AMERICA'S CUP CLASS

PUBLIC INTERPRETATION No 11

October 17, 2005

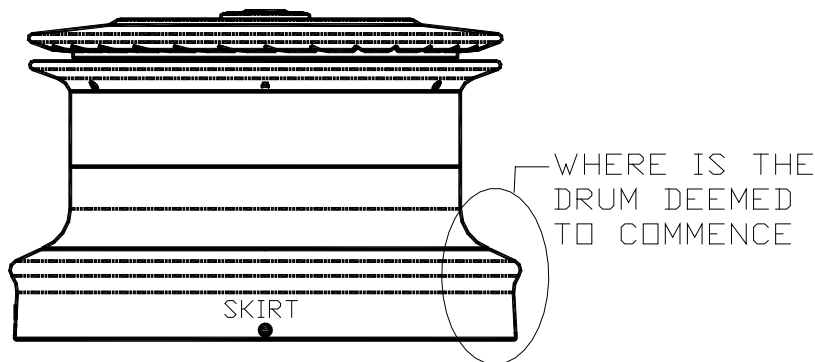
Rule 22.1 requires that a winch be positioned on or above the deck. The drum shape of the mainsheet winch is not fully analogous to the drawing in Appendix F. Could you please clarify where the drum is deemed to commence for the purposes of Rule 22.1.

For the purposes of Rules 22.1 the point at which the drum is deemed to commence is dependent on the skirt.

The skirt in the above diagram is taken to be an independently rotating part of the winch which is used as a line control device. An integral base of a winch drum as shown in Figure 1 of Appendix F whose primary purpose is to cover the internal workings of the winch is not a skirt.
